AVIATION PRODUCT ALERT

Service Alert: 070801-01

REVISION C: Revised Affected Aircraft section to reflect company name change

Figure 1. Engine System Display (Typical)

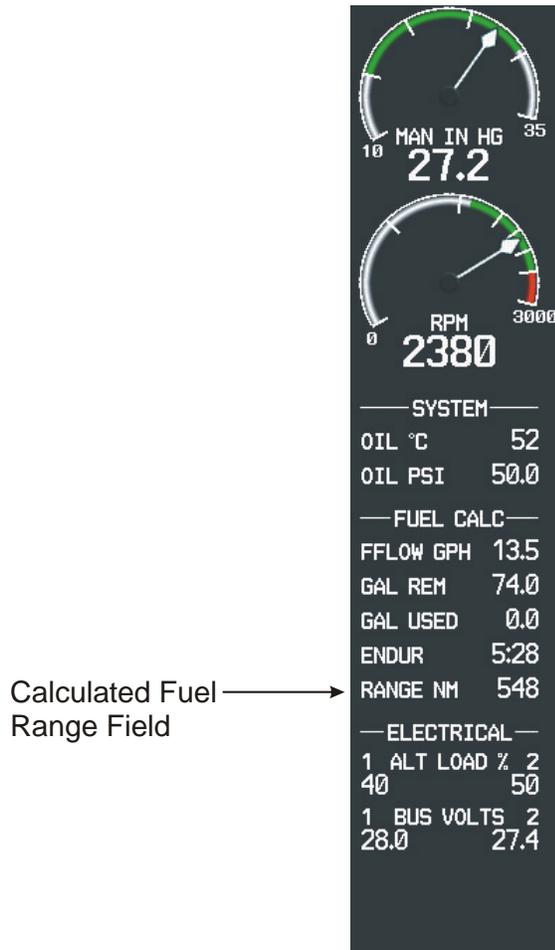
Affected aircraft use a Calculated Fuel Range Field (Figure 1) that works correctly only when the Distance/Speed Display Unit Field on the AUX - System Setup Page is set to NAUTICAL (NM, KT) (Figure 2).

When the Distance/Speed setting on the AUX System Setup Page is changed to METRIC (KM, KPH), the Calculated Fuel Range Field on the Engine System Display is inaccurate. This may cause the pilot to mistakenly believe he can fly farther than is possible on the remaining fuel.

The pilot should select and use NAUTICAL (NM and KTS) Distance and Speed units instead of selecting and using METRIC Distance and Speed units (KM and KPH).
